RE: REVISED DRAINAGE PLAN FOR TACO BELL @ COORS & HANOVER  
(J-11/D17A) REVISION DATE APRIL 9, 1987

RE: REVISED DRAINAGE PLAN FOR TACO BELL @ COORS & HANOVER  
(J-11/D17A) REVISION DATE OF MAY 14, 1987

CONFERENCE RECAP

**GRADING AND DRAINAGE PLAN**  
**TACO BELL**  
**COORS ROAD AND HANOVER ROAD**  
**ALBUQUERQUE, NEW MEXICO**

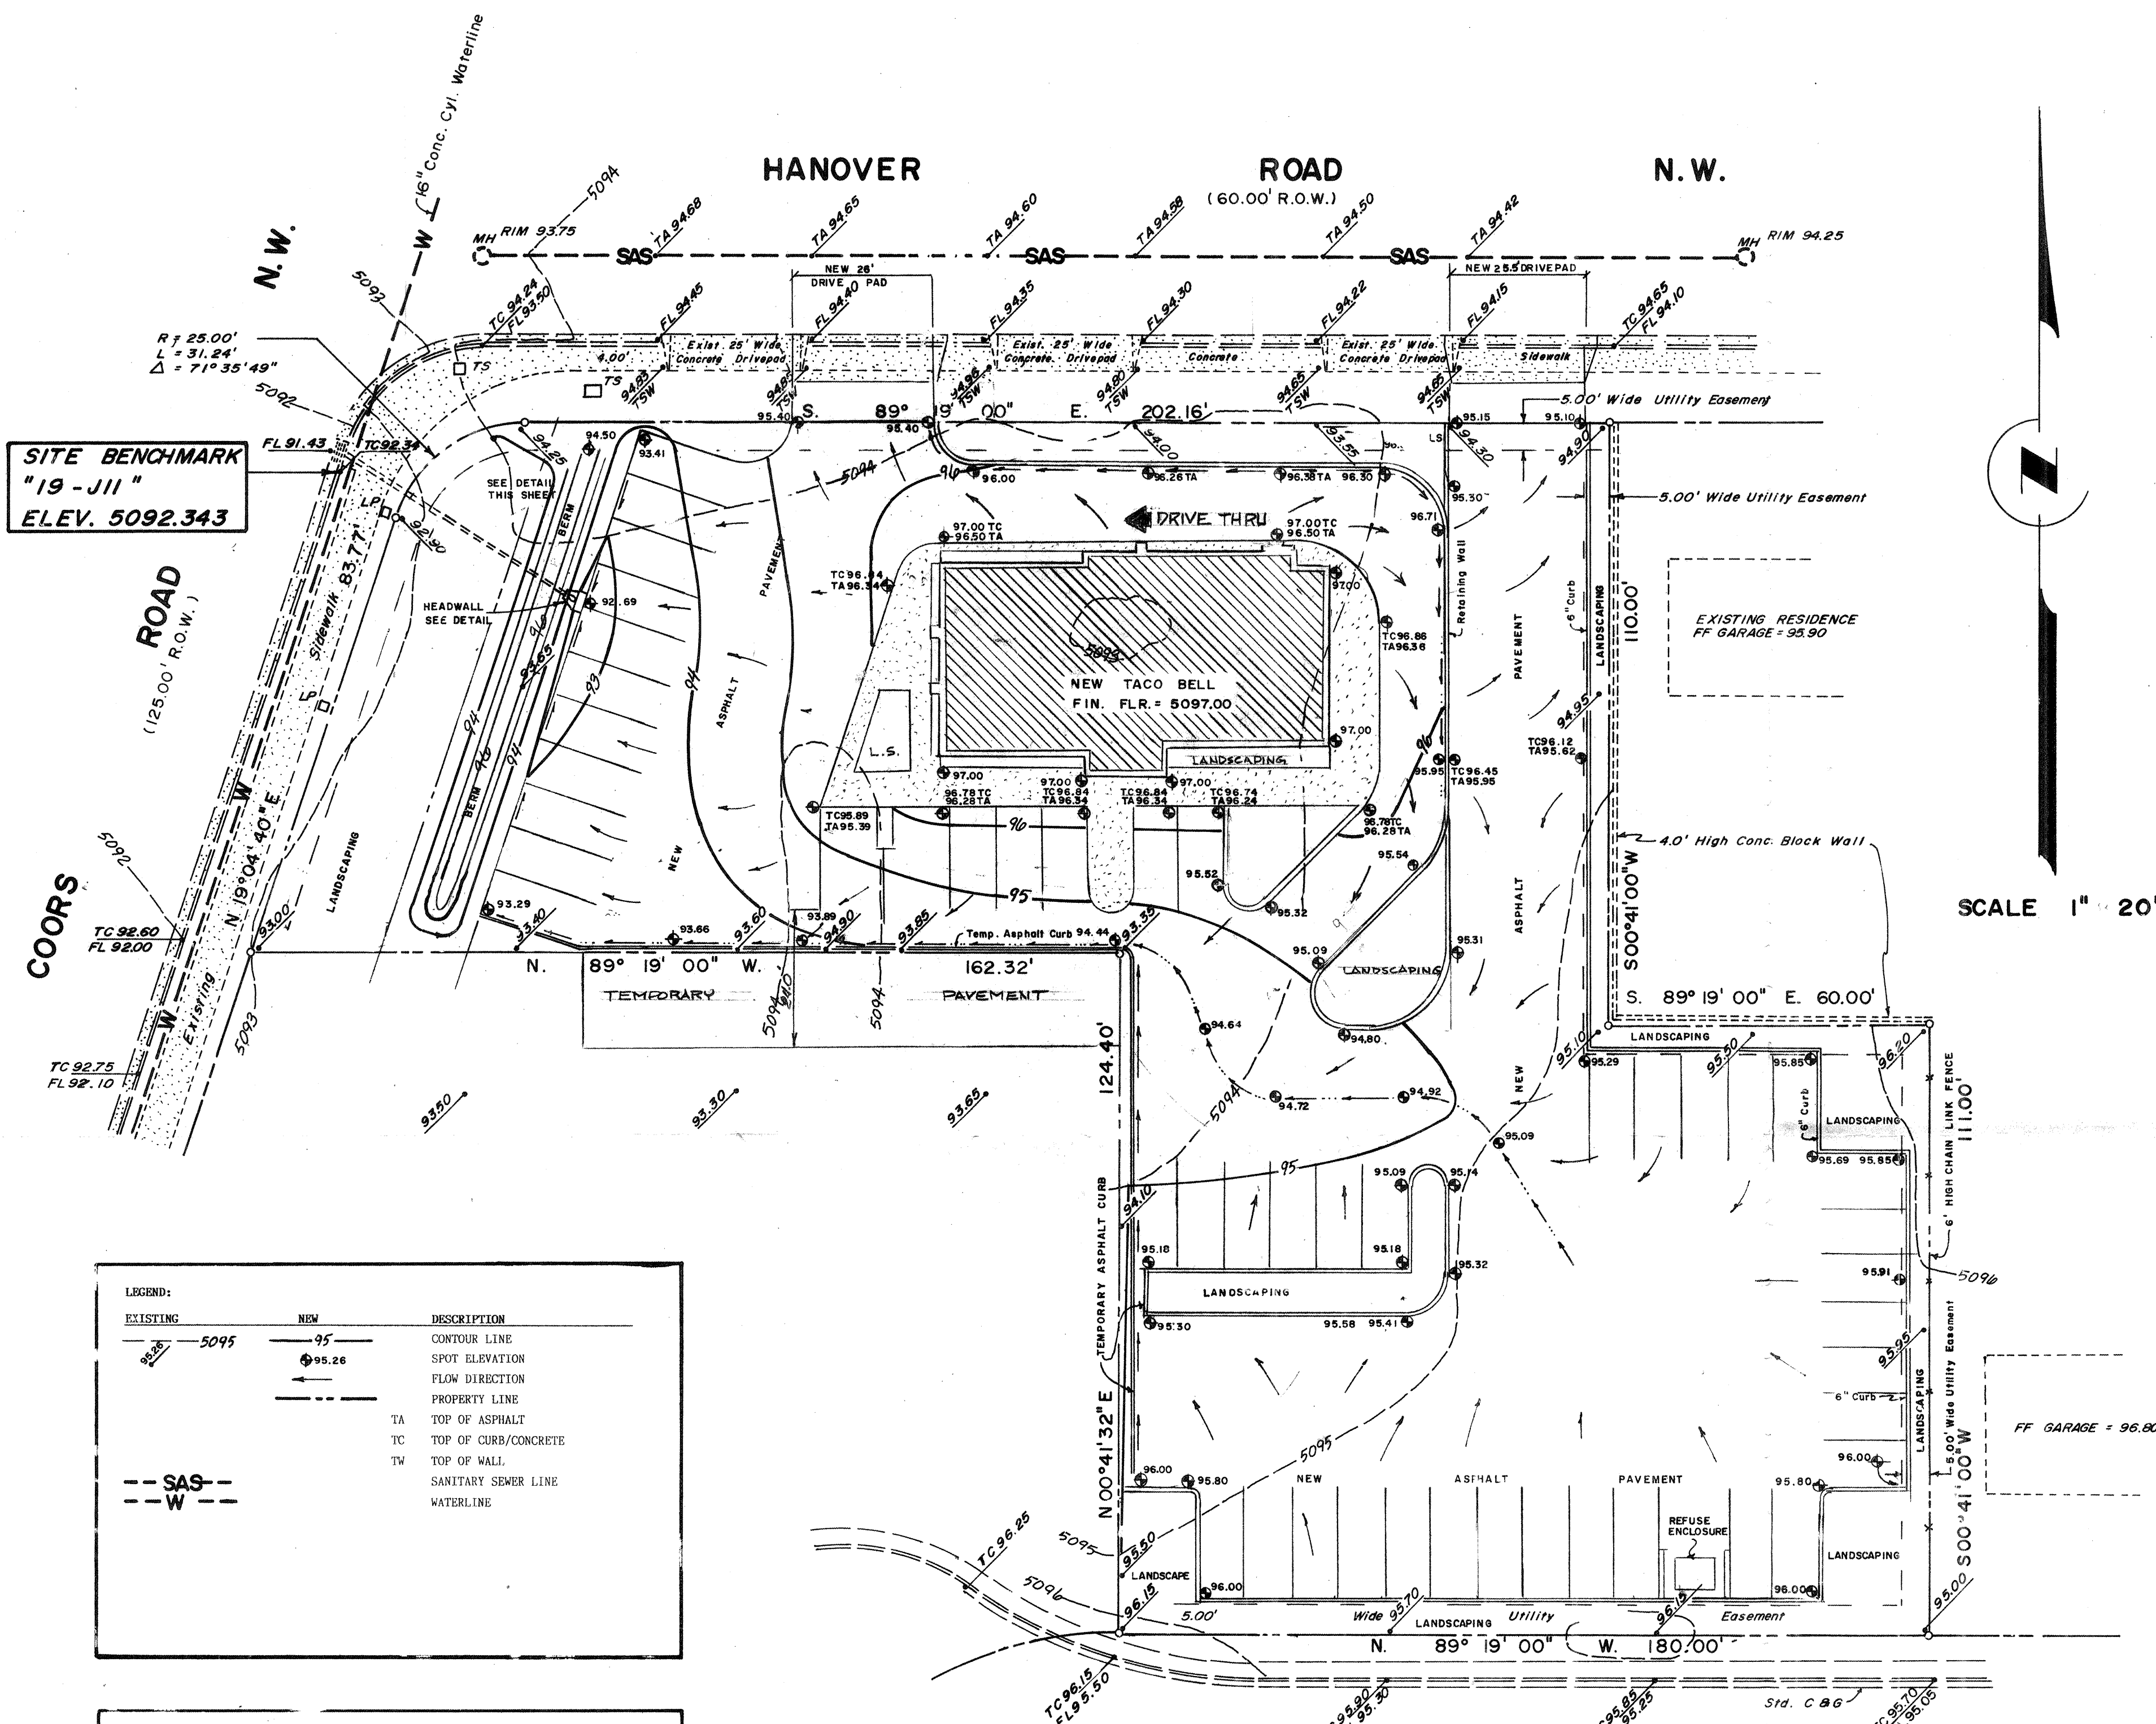
Based on the information provided on your resubmittal of April 10, 1987,  
the above referenced plan is approved for Building and Foundation Permit.

Please be advised that upon completion, we will need certification of the  
finish floor elevation.

Also, a separate permit for construction within City Right-of-Way is  
required.

Please attach a copy of this plan to the construction sets prior to  
sign-off by Hydrology.

Based on the information provided on your resubmittal of May 27, 1987, the revisions as indicated are acceptable for Building Permit approval.

Please be advised that a separate permit for construction within City right-of-way is required.
